ADDENDUM

Forestside Estates
Attmar & Palleschi Drive
Brampton, Ontario
Attn: **Vince Staffieri**

AM 08

PROJECT	**: Forestside**
PROJECT #	**: 1331.15**
DATE	**: Jan 18, 2021**

SECOND FLOOR OVERALL PLAN

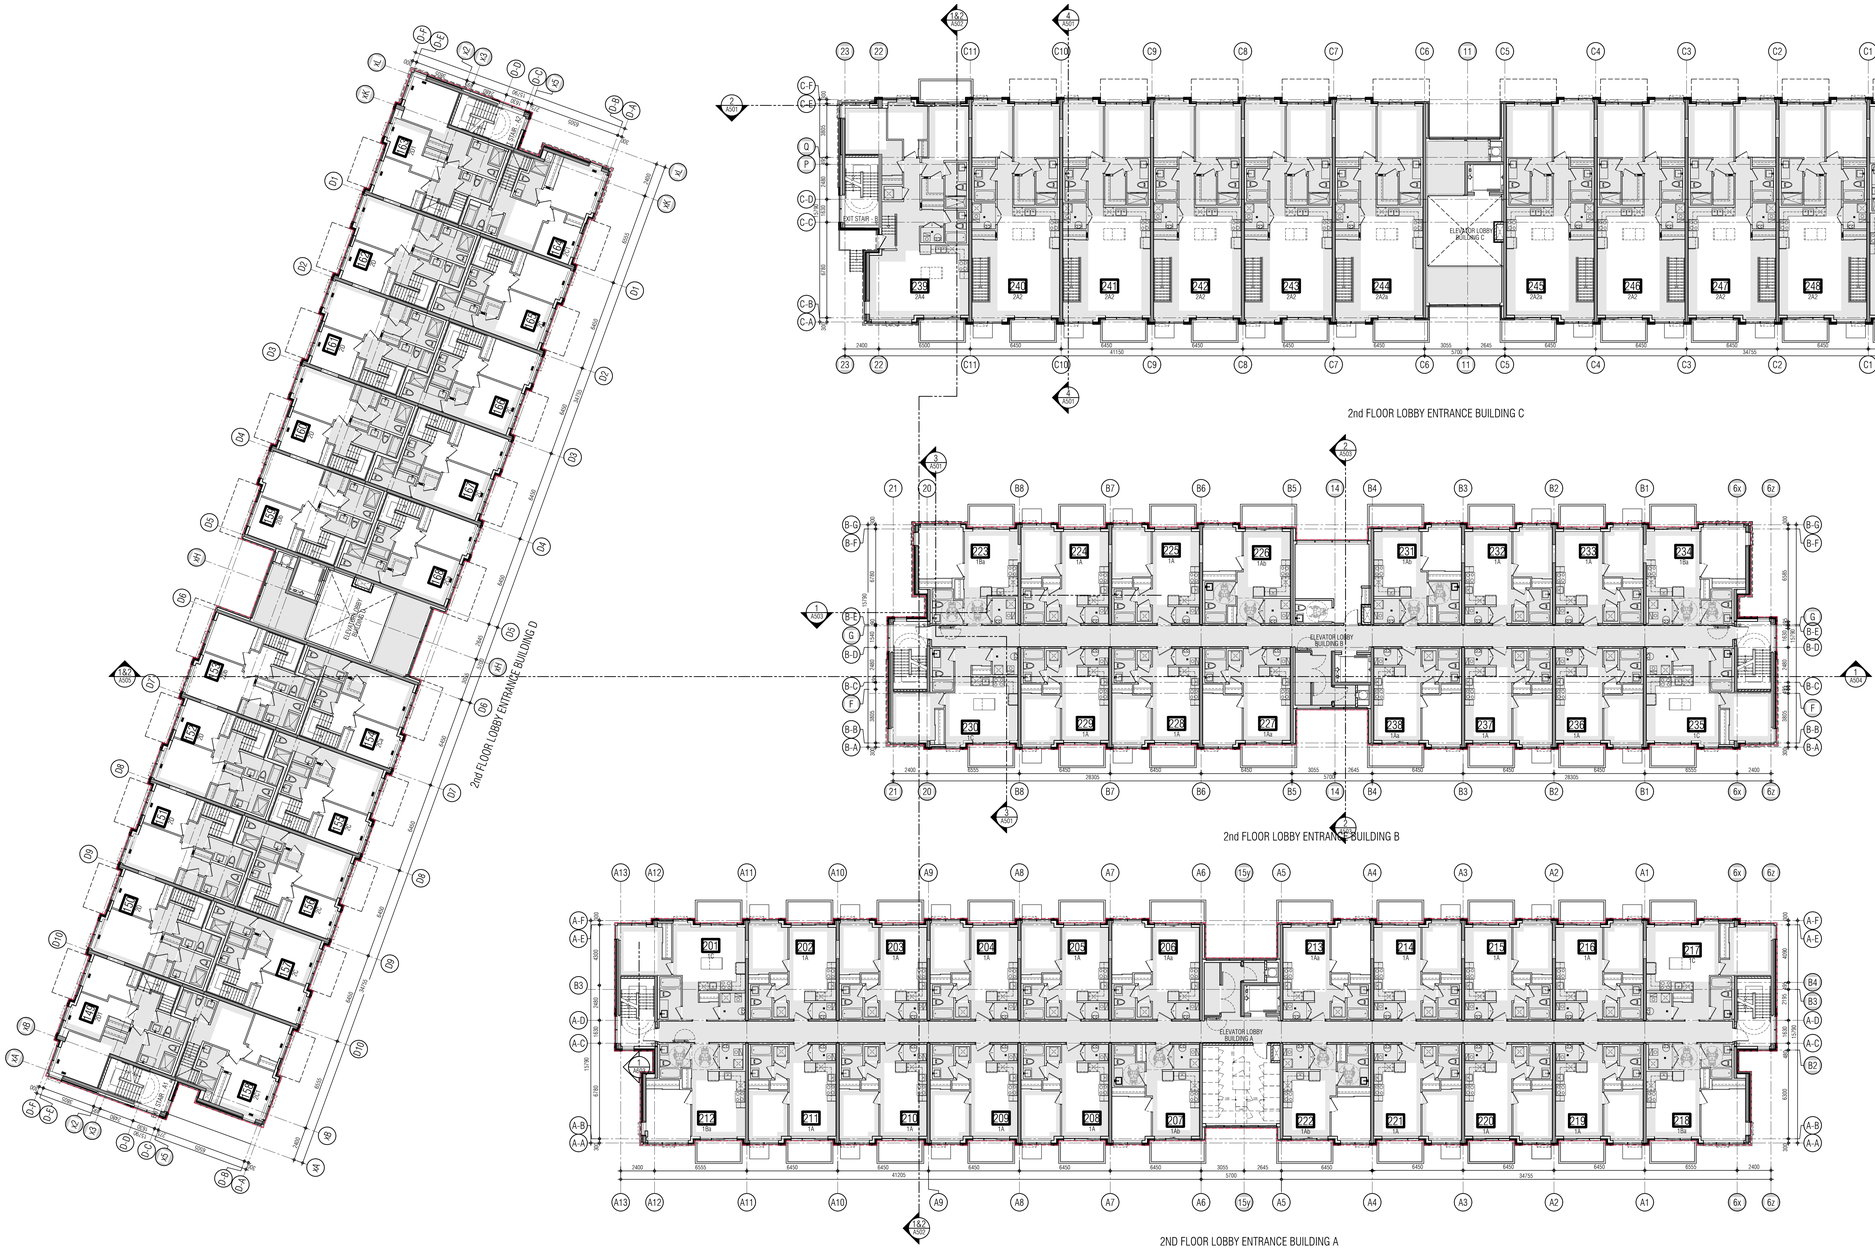
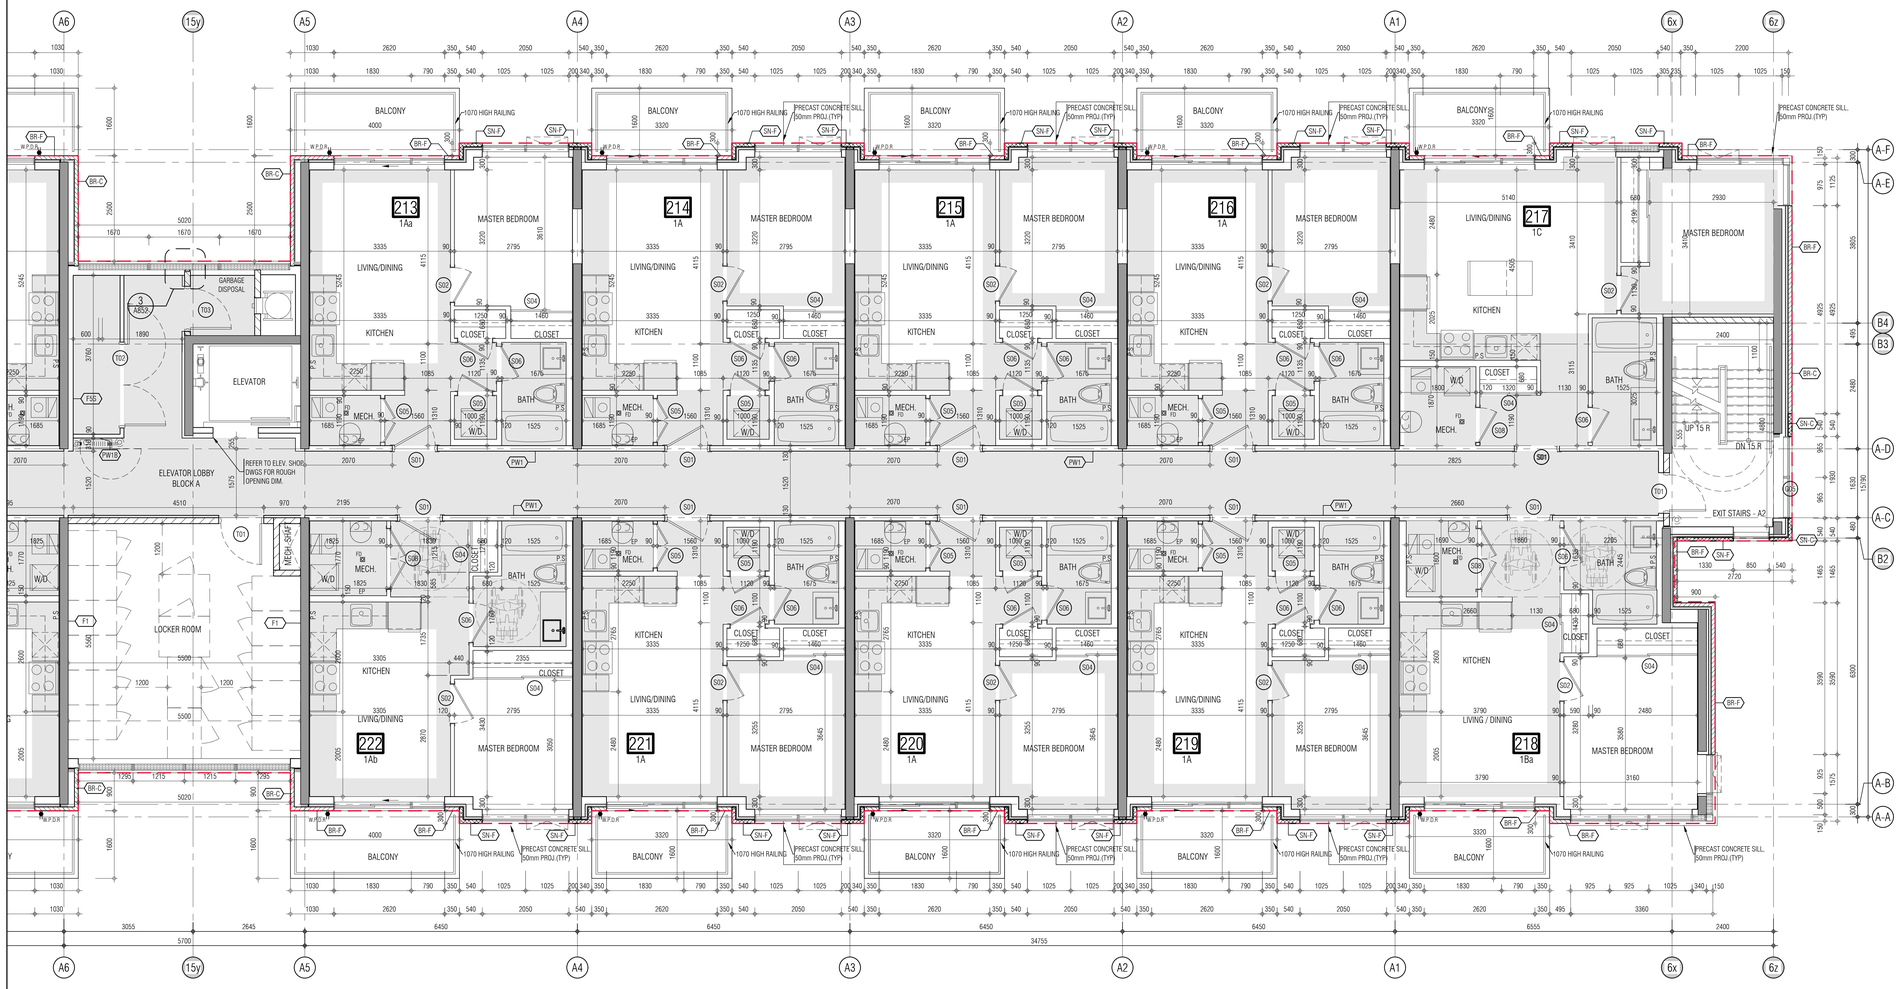
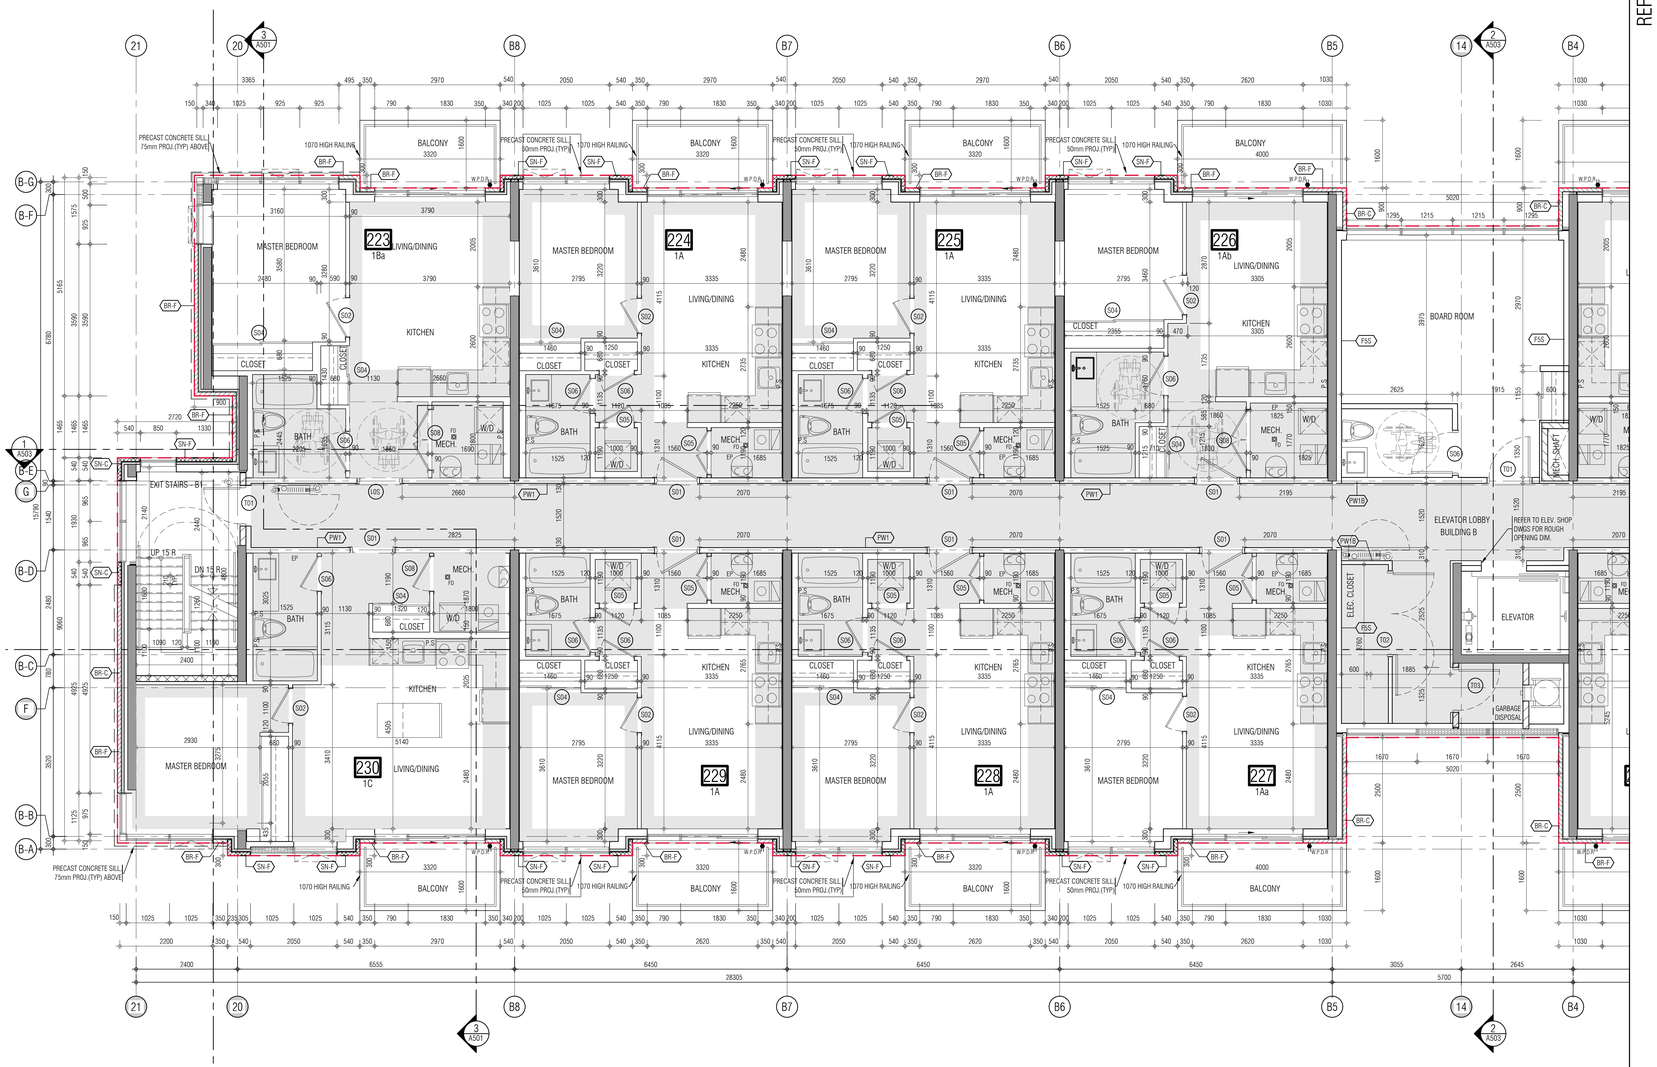
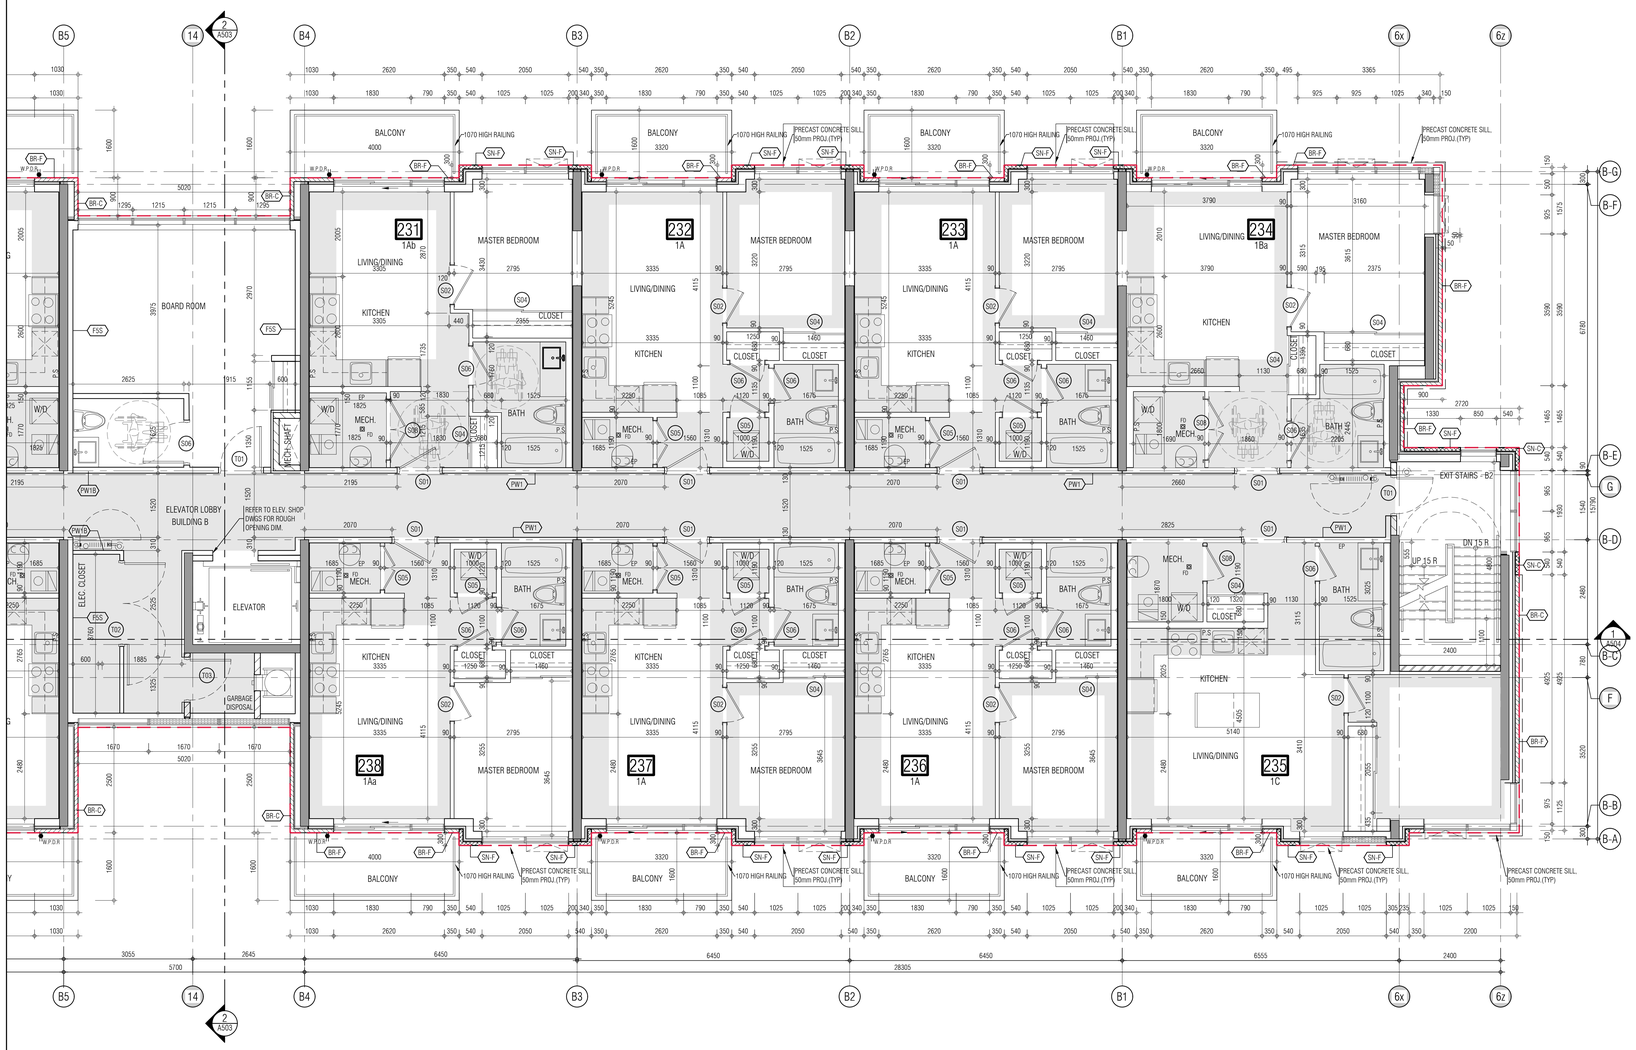
A301-A304	1st – 4th Floor Plans	• Move Blocks A and B north 286mm to comply with 0.3m easement and 3.0m minimum set back to property line as per clients request. • Move Block D up 390mm along angle north to comply with 0.3m easement and 3.0m minimum set back to property line as per clients request.
A701a-A701b	Stair Sections	• Revised dimensions on stair plans to match blocks that were moved.
